RESPONSE TO REQUEST FOR ADDITIONAL INFORMATION

APR1400 Design Certification

RAI No.: 275-8294
SRP Section: 04.02 – Fuel System Design
Application Section: 4.2
Date of RAI Issue: 10/27/2015

Figure 04.02-3-1 Simplified beam model and pluck impact simulation model

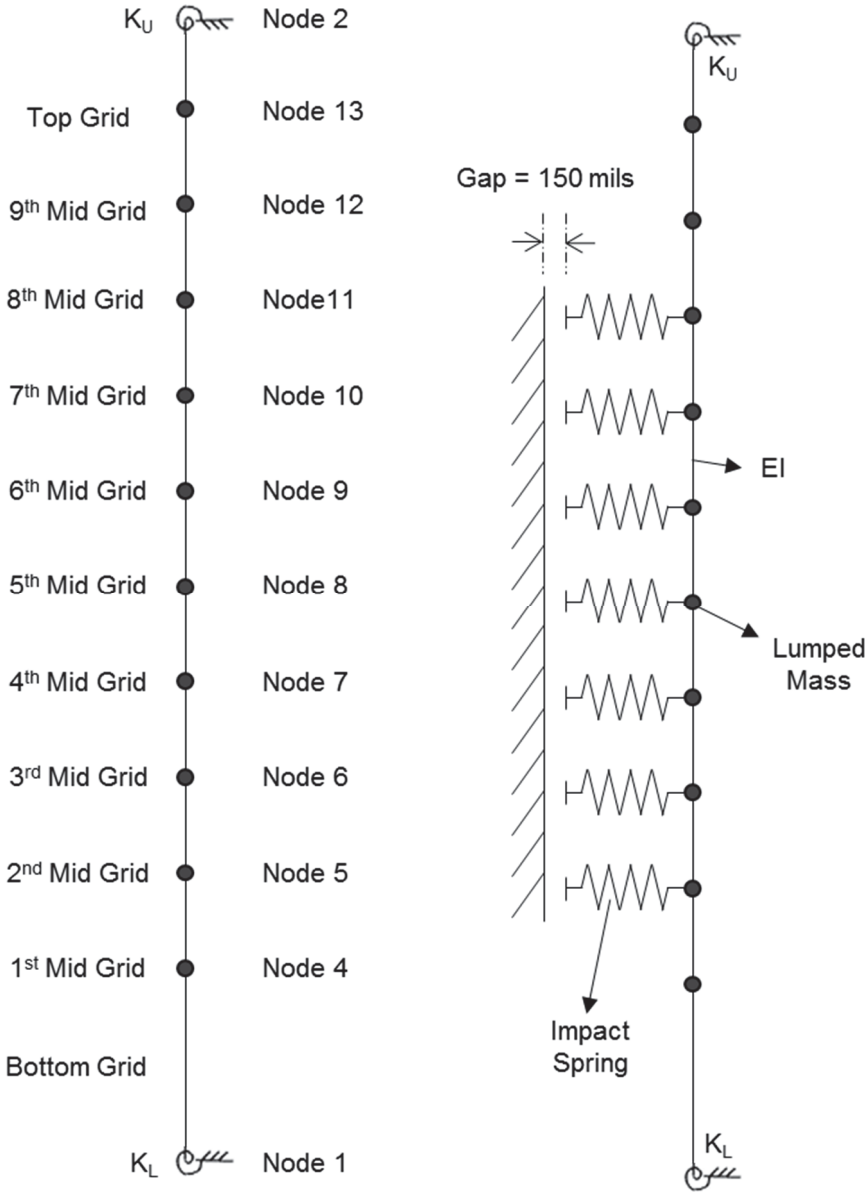
Figure A.2-6 of APR1400-Z-M-NR-14010-P demonstrates that the PLUS7 fuel assembly design exhibits nonlinear behavior, with a natural frequency that varies with vibrational amplitude. This has caused the staff to question the adequacy of the linear lateral vibrational model used in the analysis to model fuel assembly behavior.

Staff requests the applicant provide justification for the use of a linear fuel assembly model to represent the PLUS7 fuel assemblies and update the technical report, if necessary.

The fuel assembly (FA) seismic/LOCA methodology in Technical report APR1400-Z-M-NR-14010-P was prepared based on CENPD-178-P, Rev. 1-P (CENPD-178). Section 6.2.4.2 of CENPD-178 describes that one purpose for pluck impact simulation is to validate the fuel assembly modelling technique. Similar to CENPD-178, the linear model that represents the PLUS7 FAs was developed considering nonlinear characteristics at large amplitude and verified through comparison of the pluck impact test and pluck impact simulation. The comparison results clearly show that the model provides good agreement with the test data. Detailed information is described as follows:

Figure 04.02-3-1 shows a simplified beam model and a pluck impact simulation model for a fuel assembly. Nodes are located at grid center elevations and are connected to each other with beam elements. Each span weight is lumped at grid node and a rotational spring is attached at the end of each fuel assembly.

Using the force equilibrium equation with a torsional spring at each end, the normalized deflection shape of the model is expressed in terms of two non-dimensional parameters, α_1 and α_2 . The optimized values are obtained by minimizing the difference in the lateral deflection between the test result and the model as shown in Table 04.02-3-1. Using two non-dimensional parameters, α_1 and α_2 , and fuel assembly 1st mode natural frequency from the lateral vibration test, beam rigidity (EI) and two rotational spring stiffnesses (K_L , K_U) are calculated, respectively.
